Permit Type: Request for a Development Permit for Reconfiguring A Lot
Description of Proposal: 1 Lot into 2 Lots
Address of Site: 81-83 Winnetts Road, Daisy Hill QLD 4172
Real Property Description: Lot 59 on SP268614
Application Reference: RL/79/2019

**RE: REPLY TO INFORMATION REQUEST FOR APPLICATION FOR A
RECONFIGURING A LOT – ONE LOT INTO TWO LOTS AT 81-83 WINNETTS
ROAD, DAISY HILL QLD 4272**

Figure 1 – screenshot from Logan City Council PD Hub – Development Enquiry

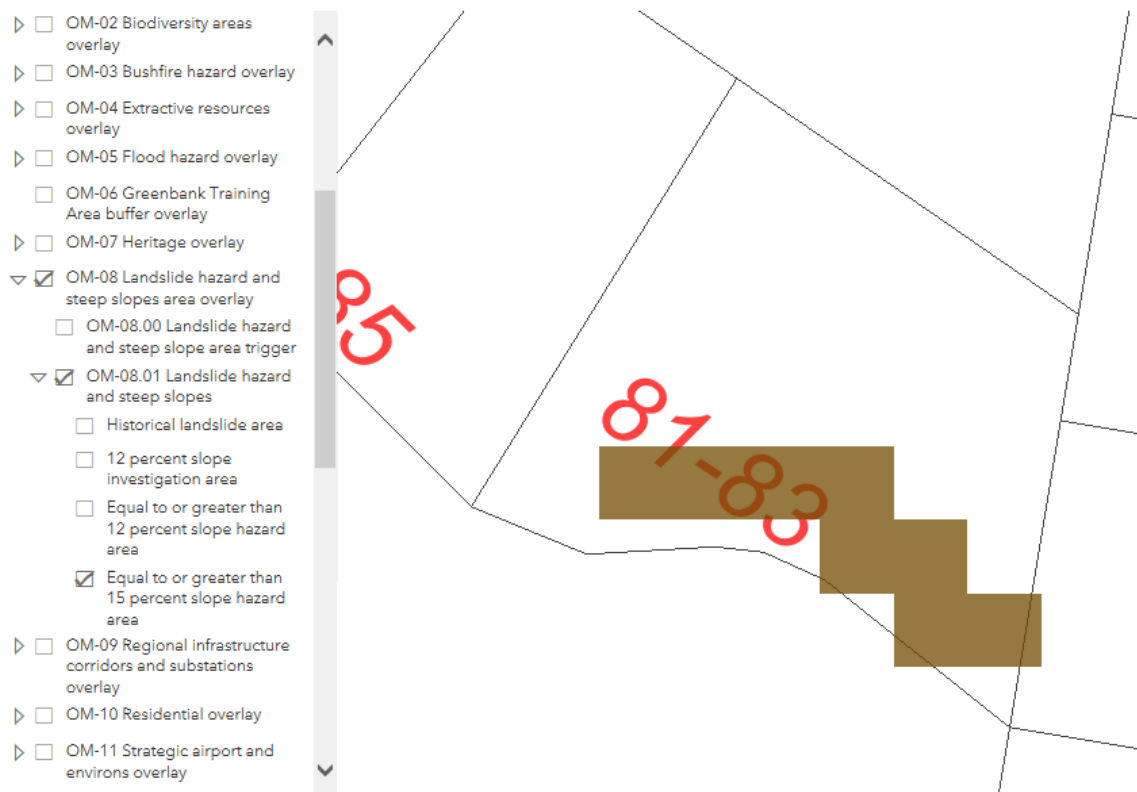
2.6 The development site is impacted by the Landslide Hazard and Steep Slope Area overlay. Provide detailed justification that assessment of the Landslide Hazard and Steep Slope Area overlay code is not required under Table 5.10.8.1 of the Logan Planning Scheme 2015 or alternatively provide an assessment against the code, including the provision of a site- specific geotechnical report.

Approximately, 20% of the site is affected by Overlay OM – 08.01 – Landslide $\geq 15\%$ slope. An existing dwelling has already been constructed on proposed Lot 61 and assessment of the overlay was undertaken with that application (Council reference number MCUC -20/2018).

The proposal complies as stated in Sections 3.2 & 3.3 of the Conceptual Site Based Stormwater Management Plan from Formation Civil dated April 2020.

In summary, the site is sloping from the Winnetts Road frontage to the rear of the development. There is approximately 2m fall from the south to north.

A geotechnical investigation is not available at the time of preparing this report; however, one will be undertaken prior to commencement of site works and building works.

Soil conditions are expected to reflect existing classifications in the area and have a potential for erosion. Specific Erosion and Sediment control measures will be put in place during construction and will be monitored by the supervising engineer.
